Please find below comments which I am submitting in response to the revised Bus and Train (BaT) project documentation released publicly on 1 December 2014. This email and the attached pdf document together comprise my submission.

Review of EIS and Revised Project Documentation for the Bus and Train (BaT) Tunnel

This document reviews the documentation for the Revised BaT tunnel released on 1-December 2014. The document focuses on changes made to the project in the review, however also makes comment on the original EIS where necessary.

FIGURE 3-10
Bus network with the Project 2021

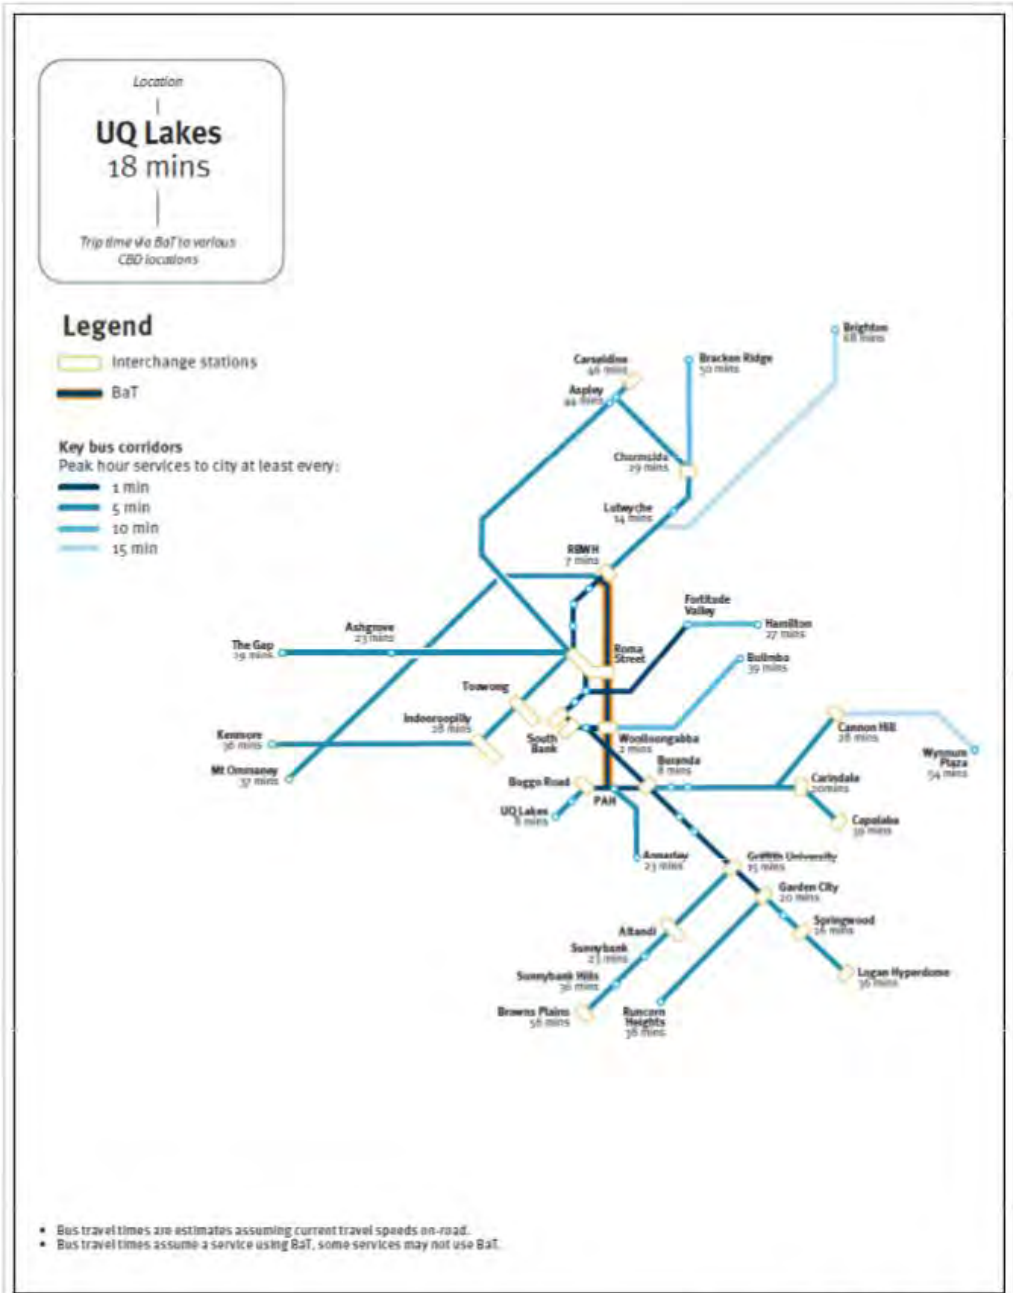
The differences are not immediately obvious, however a close inspection shows that the travel times for all BaT services from the north and west have increased by 4 minutes. For example, Chermside has increased from 29 to 33 minutes.

But where is this noted in the report? Alas, the answer is nowhere. The Project Team was aware of it and updated the diagram, but then decided to try and mislead the public by not including it in the documentation.

But the project has now increased travel times for every service using the BaT from the north and also for every cross-town service using BaT as well and not bothered to mention it.

But travel times are a key factor in determining the bus fleet requirement and you have just added 4 minutes to every service using the BaT tunnel from the north, west or cross-town service. A competent planner would realise this is a trigger to go back and look at you bus fleet requirements again, but alas, ignoring it is just so much easier.
